Item Name: Quick Release Heli-Utility-Basket™ Long, Light Lid, Spacepod™/Squirrel Cheek Comp

DART SERVICE INSTRUCTION

TO AMEND INSTALLATION INSTRUCTIONS D350-607-3 Rev.D,
INSTALLATION INSTRUCTIONS D350-607-4 Rev. C AND
INSTRUCTIONS FOR CONTINUED AIRWORTHINESS ICA-D350-607 REV. 6

A	NEW ISSUE	AJS	14.05.16
REV.	DESCRIPTION	BY	DATE
DESIGN	AJS	DART AEROSPACE LTD	
DRAWN	AJS	HAWKESBURY, ONTARIO, CANADA	
CHECKED		DRAWING NO.	REV. A
MFG. APPR.	N/A	DSI 9699	SHEET 1 OF 2
APPROVED		TITLE	SCALE
DE APPR.		LUG REPLACEMENT	NTS
DATE	14.05.16	COPYRIGHT © 2014 BY DART AEROSPACE LTD	
THIS DOCUMENT IS PRIVATE AND CONFIDENTIAL AND IS SUPPLIED ON THE EXPRESS CONDITION THAT IT IS NOT TO BE USED FOR ANY PURPOSE OR COPIED OR COMMUNICATED TO ANY OTHER PERSON WITHOUT WRITTEN PERMISSION FROM DART AEROSPACE LTD.

FIGURE 1: INSTALLATION OF D4775-041 FWD STRUT

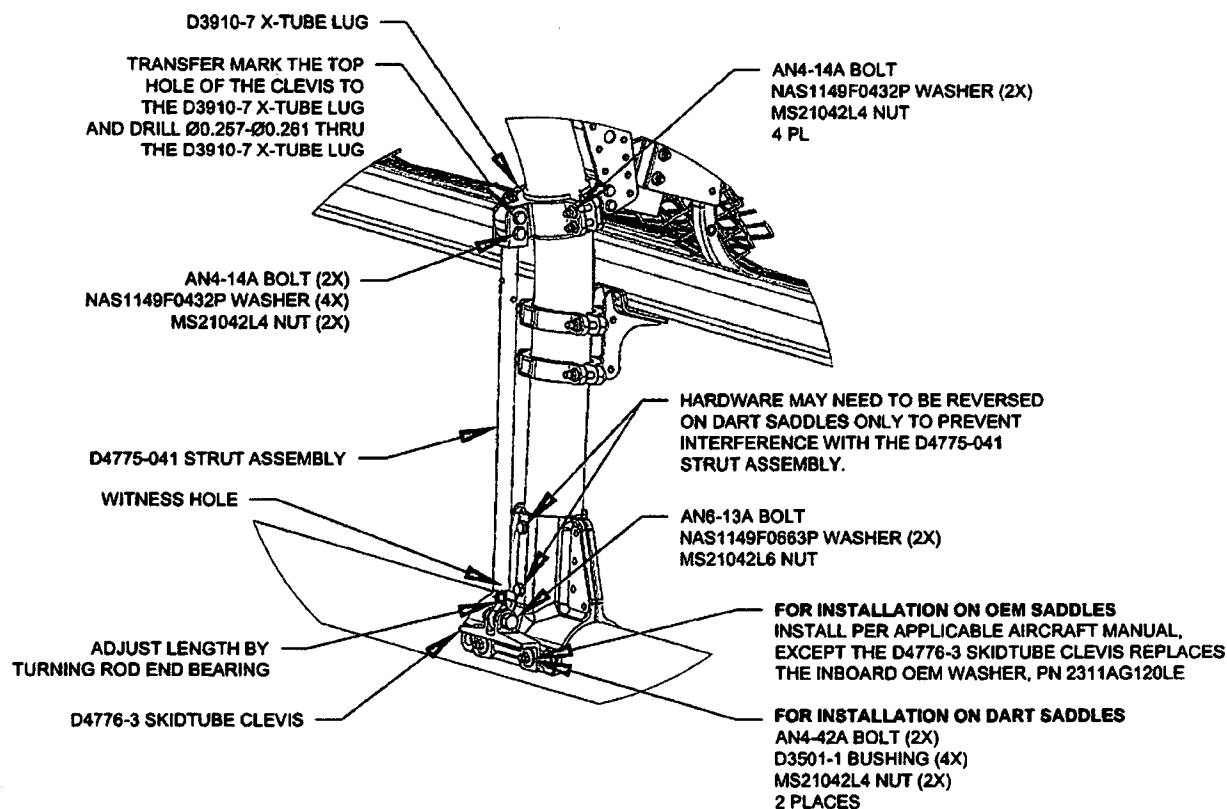
- 3.1 Substitute the Forward Lower D3910-5 X-Tube Lug with the D3910-7 X-Tube Lug as shown in Figure 1.
- 3.2 Install the forward D4775-041 Strut Assembly. Transfer mark from the upper hole on the clevis of the D4775-041 Strut Assembly to the D3910-7 X-tube Lug and drill thru the lug $\varnothing 0.257$ - $\varnothing 0.261$ as shown in Figure 1. Touch up chemical conversion coating per MIL-DTL-5541. Check the witness holes located at the bottom end of the D4775-041 Strut Assemblies to ensure that the thread from the rod end extends past the witness hole.
Torque MS21042L4/-4 nuts to 50-70 in-lbs (5.7-7.9 N-m). Torque MS21042L6/-6 nuts to 160-190 in-lbs (18.1-21.5 N-m).
- 3.3 Complete the installation in accordance with Installation Instructions D350-607-3 Rev. D or D350-607-4 Rev. C.
